TMI-09-107
November 9, 2009

Three Mile Island Nuclear Station, Unit 1
Renewed Facility Operating License No. DPR-50
NRC Docket No. 50-289

Subject: Response to Request for Additional Information Regarding Generic Letter
2004-02

Photograph 8: Post Debris Addition TMI Unit 1 Test 11/07 (southwest corner)

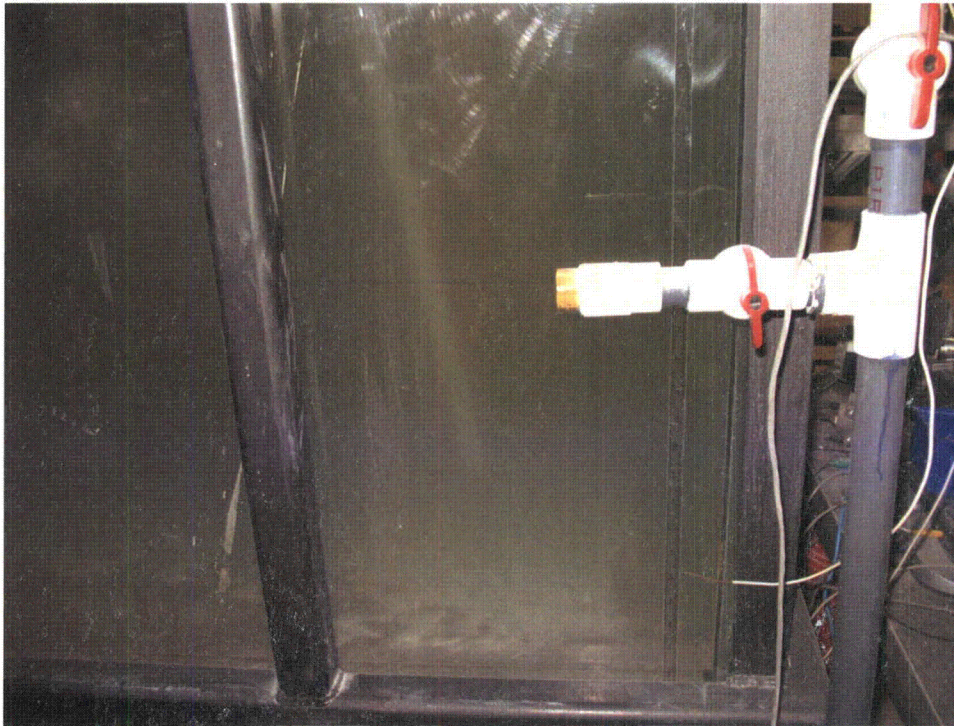
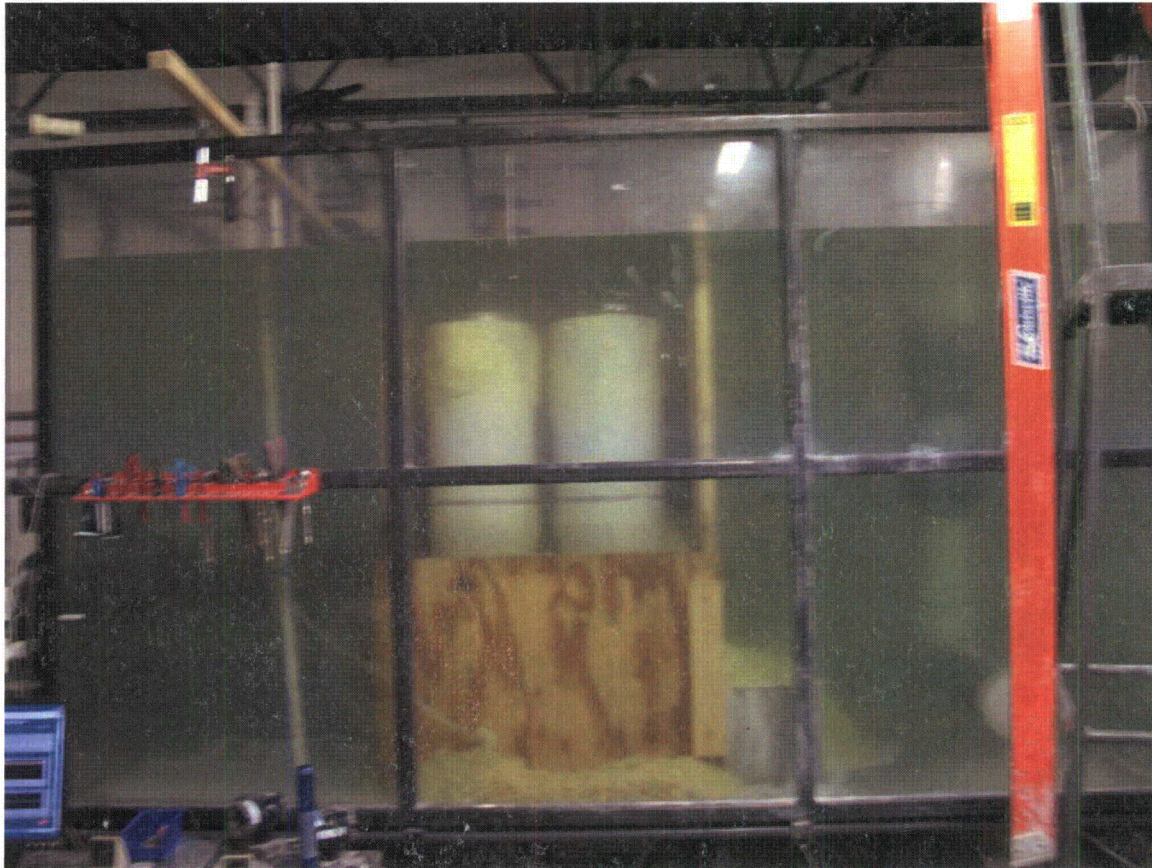
The staff requested additional information on the size distribution of fibrous debris used during testing and requested that the licensee provide information that justified the fibrous debris used during testing. The licensee stated that small fines were used. However, the staff guidance requests that the fibrous debris sizing be further broken down into small and fine debris categories. Current staff guidance states that thin bed testing should be conducted with only fine (easily suspendable) fiber (until all predicted fine fibers have been added to the test). The licensee response to the RAI did not address the referenced guidance. It is possible, but unlikely, that a thin bed test conducted in accordance with the latest guidance could result in

higher head losses than were attained during the TMI-1 testing. It is more likely that the full load test, if conducted with prototypically sized fiber could have resulted in higher head losses. The licensee should provide information that justifies that the head losses attained during testing were not influenced non-conservatively by the sizing of the fibrous debris used during testing.

Alion incorporated improvements to the test tank that would enhance agitation of the water to provide better suspension of debris. The barrel diffuser used in the March 2007 testing was replaced with a "tee-sparger" piping system. This arrangement distributed the water at floor level as it was re-circulated from the strainer plenum back into the tank. This configuration also generates somewhat higher velocities from water entering the tank than were achieved with the barrel diffuser. The distribution piping was configured such that the debris accumulated on the strainer screen would not be disturbed by discharge from the sparger.

At the conclusion of the test, it could be seen that Alion's improvements to tank agitation methods greatly reduced the amount of settled debris. Photograph 8 below illustrates the tank condition after all debris had been introduced to the experiment. This photograph shows the southwest corner of the tank and can be directly compared to Photograph 6 from the March 2007 test (1B).

After all debris had been introduced to the tank and consistent attempts to keep the debris in suspension were performed, a small amount of fibrous debris could still be observed in isolated areas of the test tank floor. Photograph 9 shows the final condition of the test. By observation, the only debris component observed to have settled is the largest fiber class. The majority of the fibrous debris, along with the particulate and chemical precipitate debris had accumulated on the sump screen. The amount of settled fiber at the end of TMI, Unit 1 November 2007 Test 2B is estimated to be approximately 10%. Based on the clarity of the water, the particulate has been filtered and the head loss is in general higher with higher particulate to fiber ratios assuming fiber loads that do not fill in the interstitial volume (which is the case here). The head loss at this point is dominated by the tightly packed debris layer on the surface of the screen. The settled debris on the floor is extremely loose and non-compacted; therefore, the impact of this debris on the measured head loss would not be significant. As seen in Photograph 9, there is already a considerable amount of the non-compacted debris within the sump box. Based on this, the settled debris does not have a significant effect on the results.

Figure 9: LPI NPSH – EQ Reactor Building Response – Case IV (Hours)

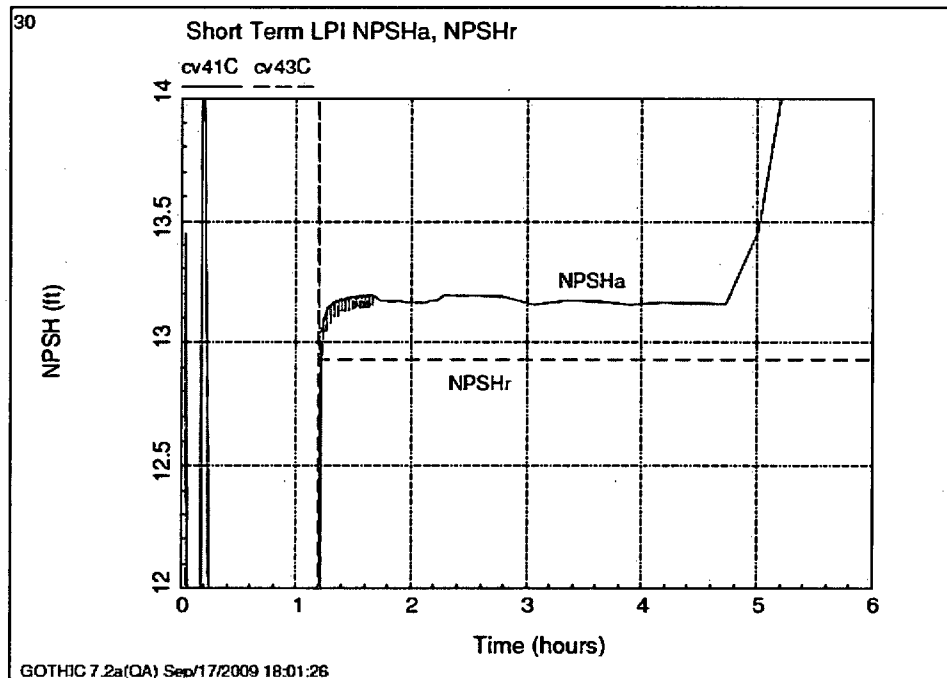
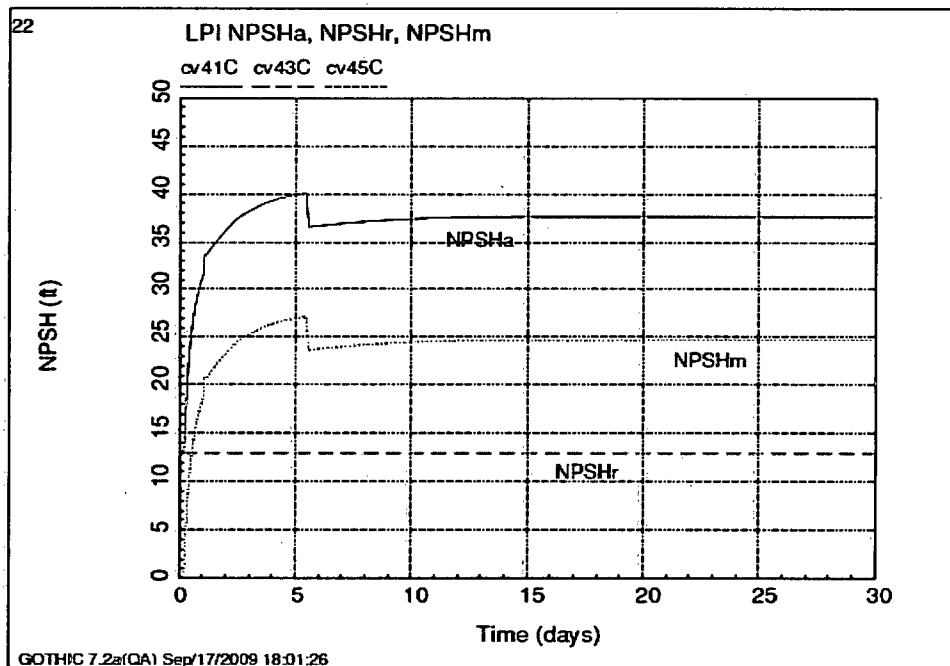
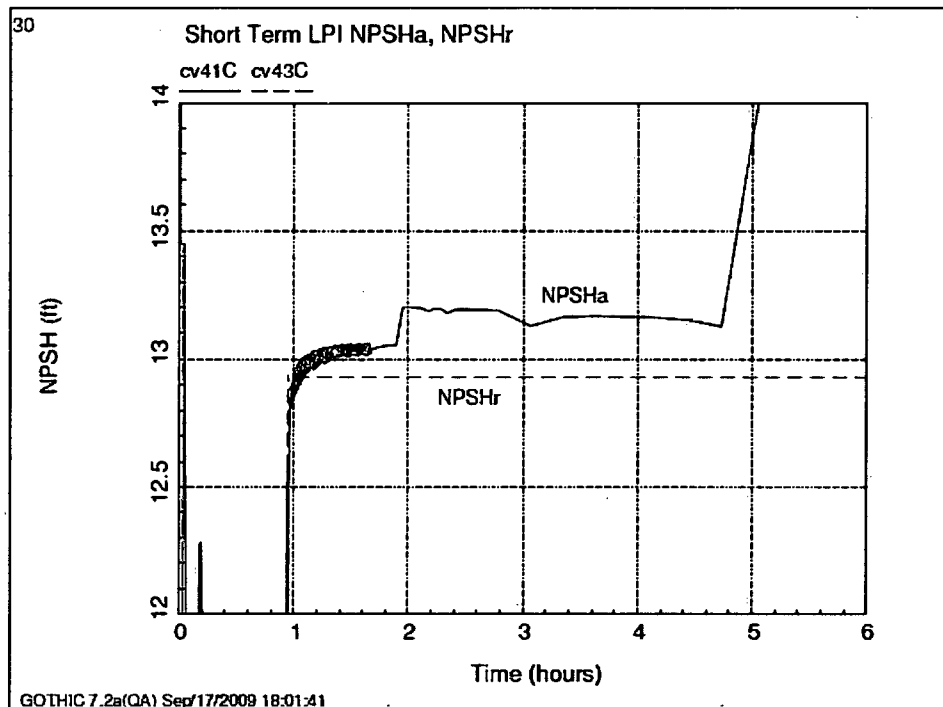
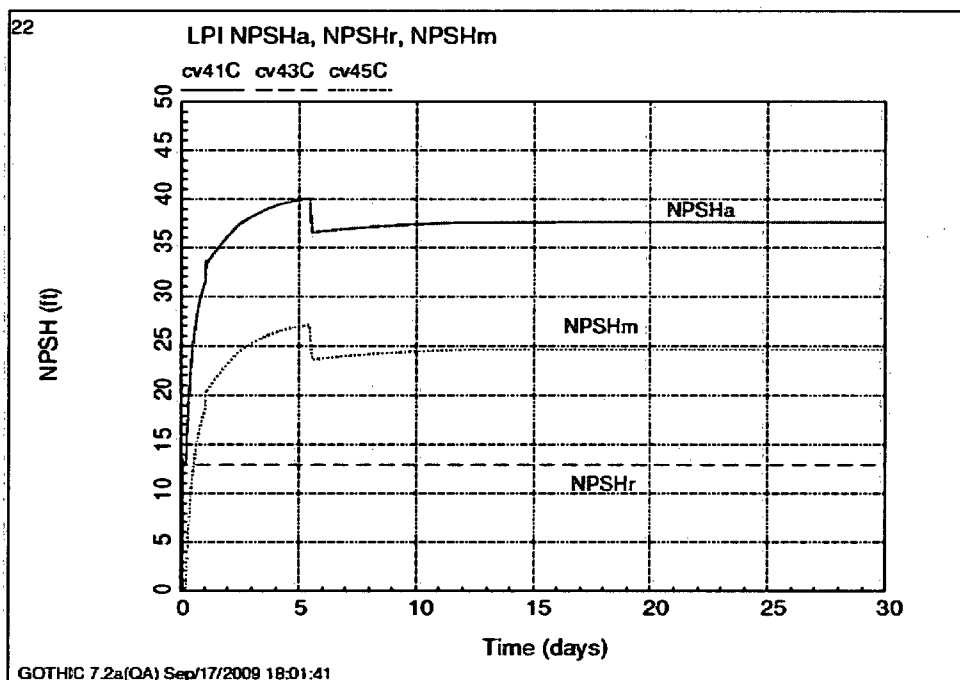
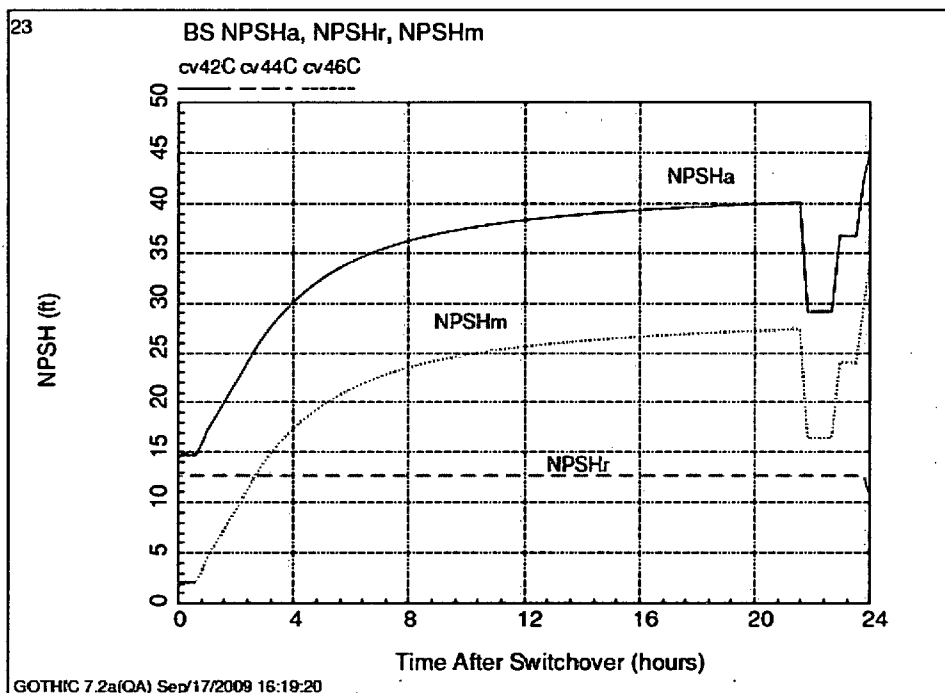
The staff requested that the licensee provide a more detailed description of the NPSH margin calculation methodology, including a description of the time-dependent analysis specifying selected values for NPSHa (NPSH available) and NPSHr (NPSH required) throughout the mission time. Although some information was provided in response to this request, the staff did not consider the response complete because sufficient information was not provided for the dependence of NPSHa on the sump pool water temperature as well as the time-dependence of the NPSH margin. While it is clear that the available margins are very small at the worst point in the limiting accident sequence (i.e., the minimum NPSH margin is 0.1 ft), it is unclear to the staff when this minimum margin occurs, how long it persists, and how much margin exists at other times during the accident. Therefore, to fully resolve this RAI, the staff is requesting that the licensee provide plots of NPSH margin versus time (or sump temperature if this parameter was used in lieu of time) for the limiting case (or cases) for both the LPI and building spray (BS) pumps that demonstrate the periods of minimum NPSH margin and the behavior of the NPSH margin as a function of time (or sump temperature).

The limiting case for LPI pump NPSH margin is EQ Case V (Table IX, Attachment 5). Short and long term NPSH plots for both Cases IV and V for the LPI pumps are provided.

The limiting case for BS pump NPSH margin is EQ Case I (Table X, Attachment 5).

Figure 14: LPI NPSH – EQ Reactor Building Response – Case IV (Hours)

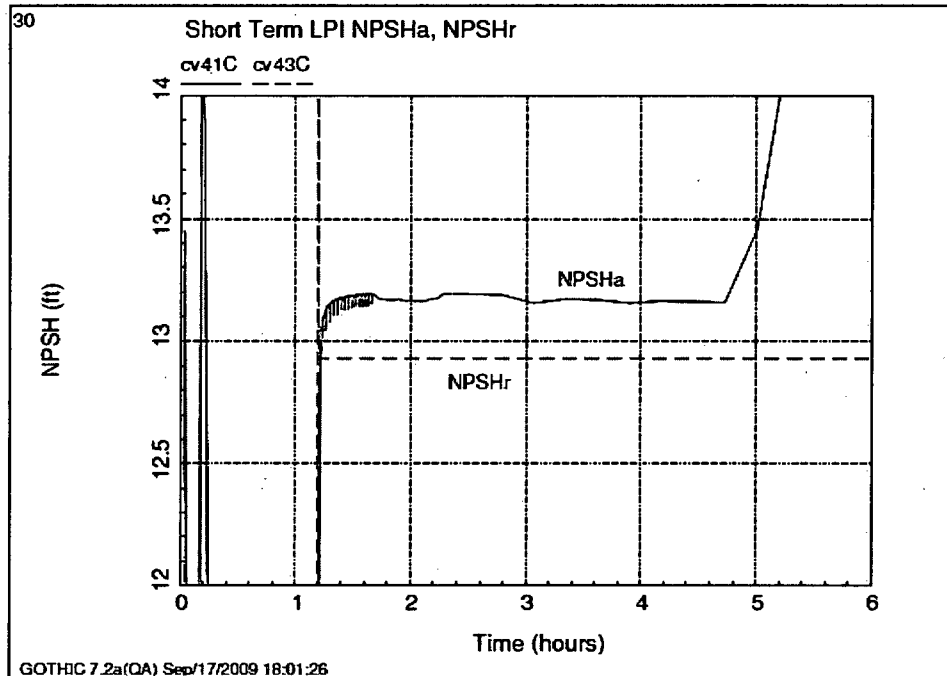
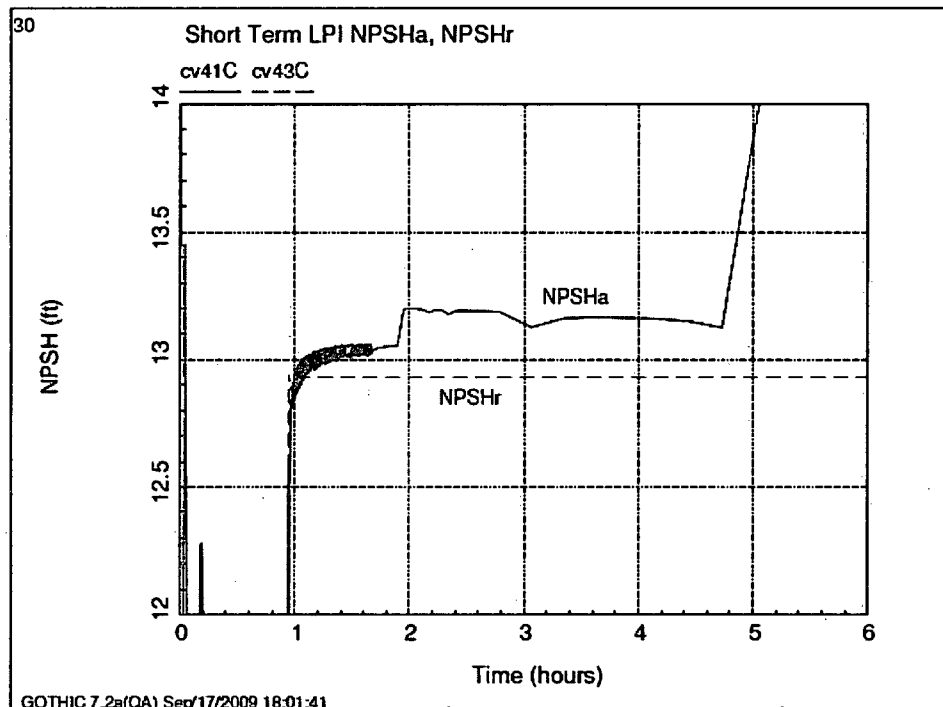
The staff requested that the licensee provide a discussion of how the single failure criterion was used in determining the bounding NPSH margin and why there is confidence that the worst-case single failure was identified and considered. The licensee's response to this item described a single failure of an LPI pump as being the worst-case single failure. Upon considering the NPSH margin results in Table 14 in the supplemental response, as well as the response to RAI 17 that indicates that maximizing reactor building cooling is considered a limiting condition, the staff questioned whether a configuration with one operating LPI pump and two operating BS pumps would be bounded by the results presented. For the case of two operating LPI pumps, having two operating BS pumps led to the minimum NPSH margin, but a corresponding case was not analyzed for single-train LPI operation. Please either (1) provide a basis for considering the configuration of one LPI pump and 2 BS pumps operating to be bounded by the cases analyzed or (2) provide a basis for concluding that this operating configuration will not be implemented following a LOCA (e.g., it would not be allowed by emergency procedures).

The TMI, Unit 1 NPSH Margin Analysis has been revised to add the additional case of a single LPI pump operating with both of the BS pumps operating. The minimum NPSH margin for this Case (Case V) was slightly lower than for Case IV as shown in the plots below. However, the minimum NPSH margin remains at 0.1 ft.

A graph of NPSHa and NPSHr versus time for the first six hours of operation in the recirculation mode for EQ Case IV is provided below. The minimum margin for this case was listed as 0.1 ft in Table 14 (Reference 1). When the scale of the plot was expanded and compared to the result for Case V, it is evident that the NPSH margin for Case IV is initially slightly greater than the margin for Case V. The minimum margin for Case IV provided in the revised Table 14 (Attachment 5) is 0.2 ft based on the stable NPSH margin that exists after recirculation conditions are established.

A graph of NPSHa and NPSHr versus time for the first six hours of operation in the recirculation mode for EQ Case V is provided below. The minimum stable NPSH margin for the first hour of operation is 0.1 ft. After 1 hour, the first BS pump is secured as described in the previous response to Issue 3f.10 (Reference 1). After the first BS pump is secured, the configuration is then equivalent to Case IV and the margin increases to 0.2 ft.
